**CITY OF EYOTA
PLANNING COMMISSION MEETING MINUTES
JUNE 9, 2020**

PUBLIC HEARING Aurora Rising Fist Addition Preliminary Plat: See "Exhibit B"
Motion was made by Lief Hughes and seconded by Janet Hughes to close the regular meeting and open the public hearing. Ayes 5, Nays 0. Motion carried.

PUBLIC HEARING Arendt Subdivision Preliminary Plat: See "Exhibit C"

AURORA RISING FIRST ADDITION PRELIMINARY PLAT
 SHEET 1 OF 1 SHEETS

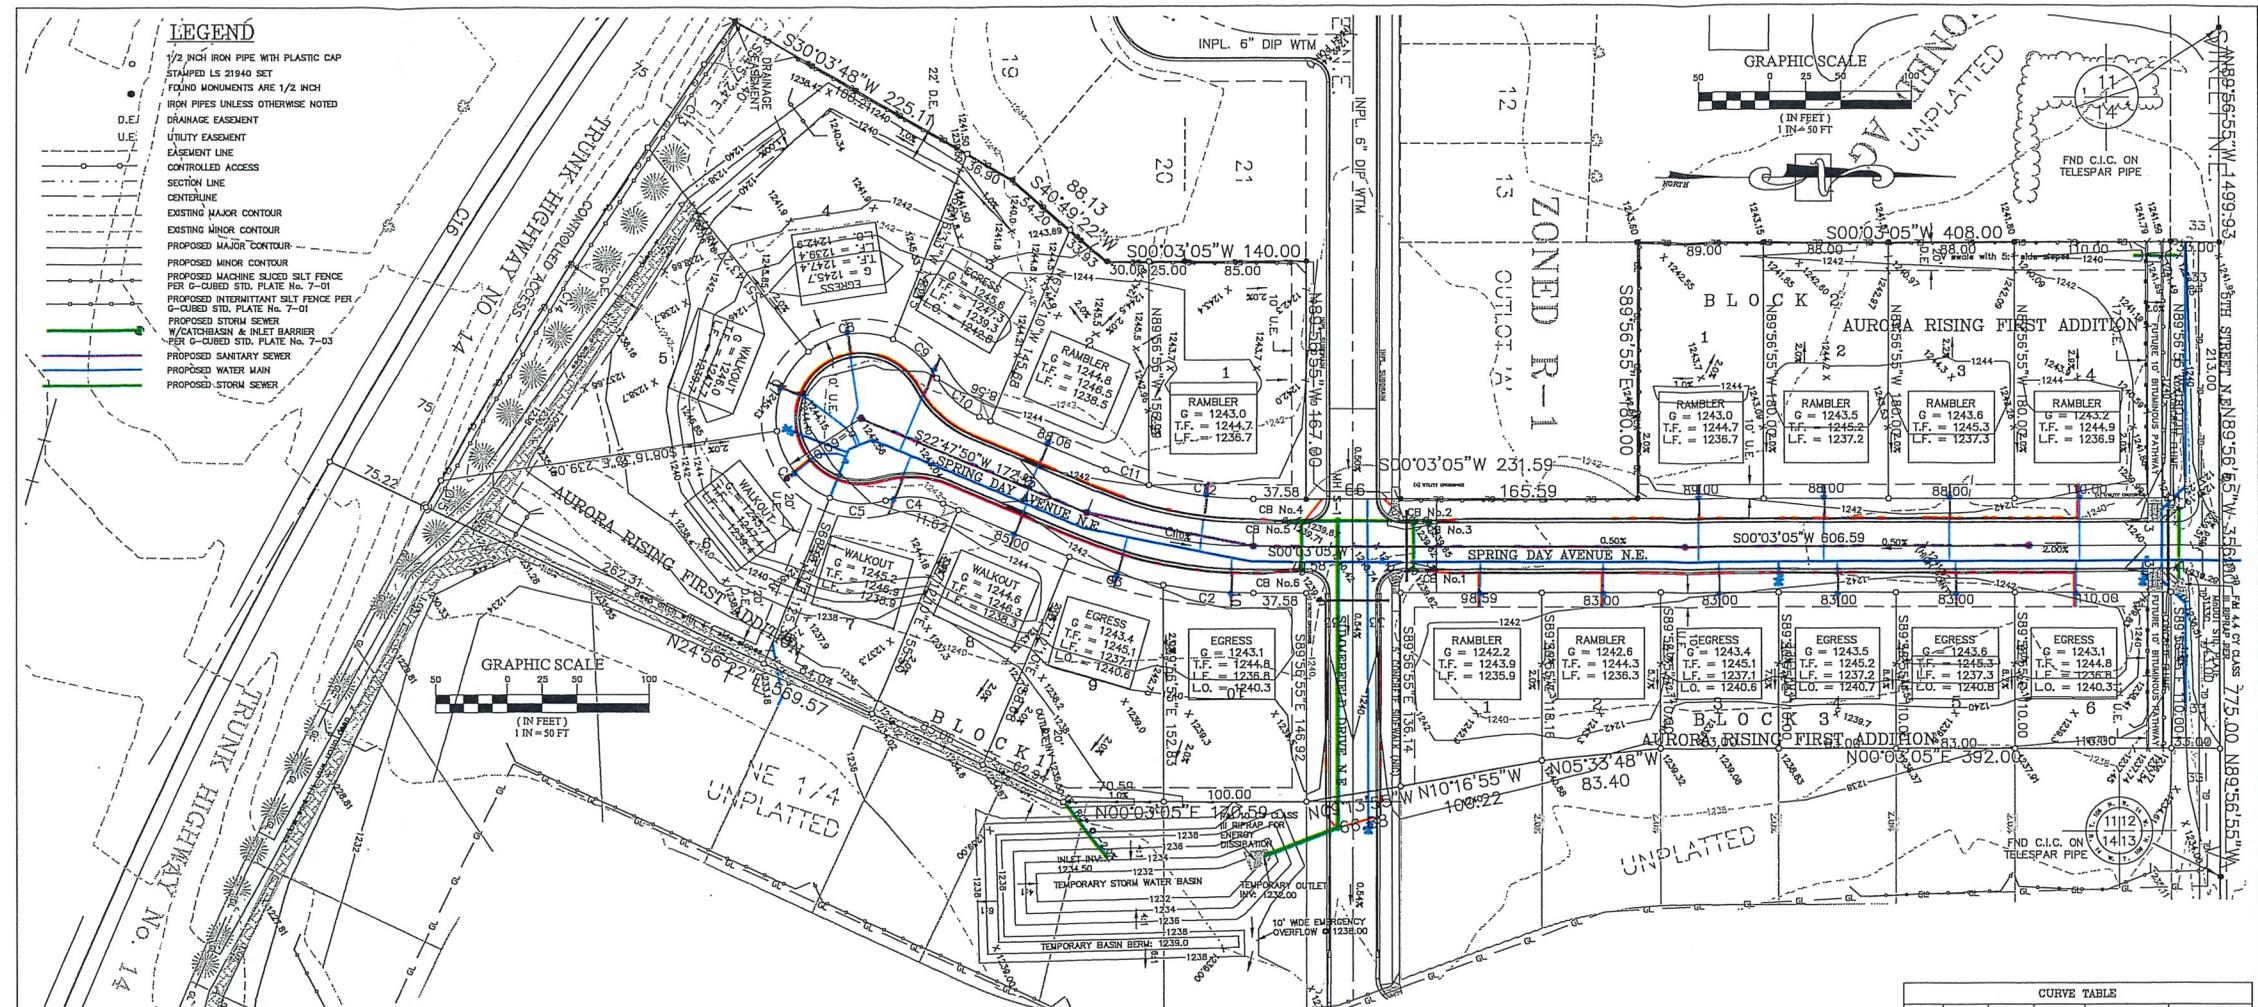
Spafford read through WHKS's comments: all permits will be required before construction, city engineering expenses need to be submitted to be included in the development agreement, construction schedule will be submitted later, Spring Day Avenue NE should be changed to

Spring Day Court NE for consistency, riprap will be added to the storm water basin, Atas 14 rainfall event hydraulic calculations should be submitted, street right of way on Fifth Street should be shown on plans, and a temporary hydrant should be installed. All these were agreed to by Griffin and the Developer.

Spafford: where water mains were previously a dead end, it was not good planning. Sikkink agreed that the main in this area is currently dead ended and with out enough use rust builds up and water quality goes down. A loop provides better fire protection and better flow. Loops are better as they minimize how many users need to be shut off if that is needed. Griffin suggested they can work with the Council to decide if a loop will be installed and how to be reimbursed for the installation cost. Spafford agreed it is appropriate to work with the Council on that and it is good planning for the future.

PRELIMINARY PLAT FOR ARENDT SUBDIVISION

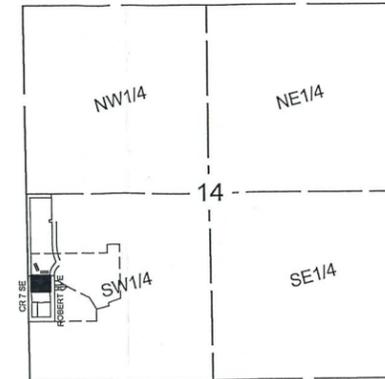
Spafford went through the city Engineers comments: no variance requested, no park required and that should be noted in the development agreement, SAC/WAC fees should be noted in the development agreement, required permitting is being worked on, Craig Britton, developer's

Engineering costs are being finalized by Arendt, too early for construction schedules, hydraulic calculations have been submitted but not yet reviewed, storm water pollution prevention plan is required as this project is over one acre, water and sewer services need to be labeled as private. Spafford reiterated this must be understood by everyone, these will not be the city's responsibility; they will be the homeowners. The water main should be labeled as a minimum 7.5 foot cover. The street repair to Robert Avenue must be to city specs; inside the development area is not included.

Sikkink noted the storm water emergency overflows for 100-year storm needs to be provided and labeled. The grading around the parcel looks like swales. It is not flat as they are trying to control the storm water and slow it down before entering the ditch. Everybody needs to know these are flatter grades and later unit owners can not request the city to fix the grading and standing water issues. It is right here as part of the plan. It is being requested to be noted on the plans to acknowledge potential problems.
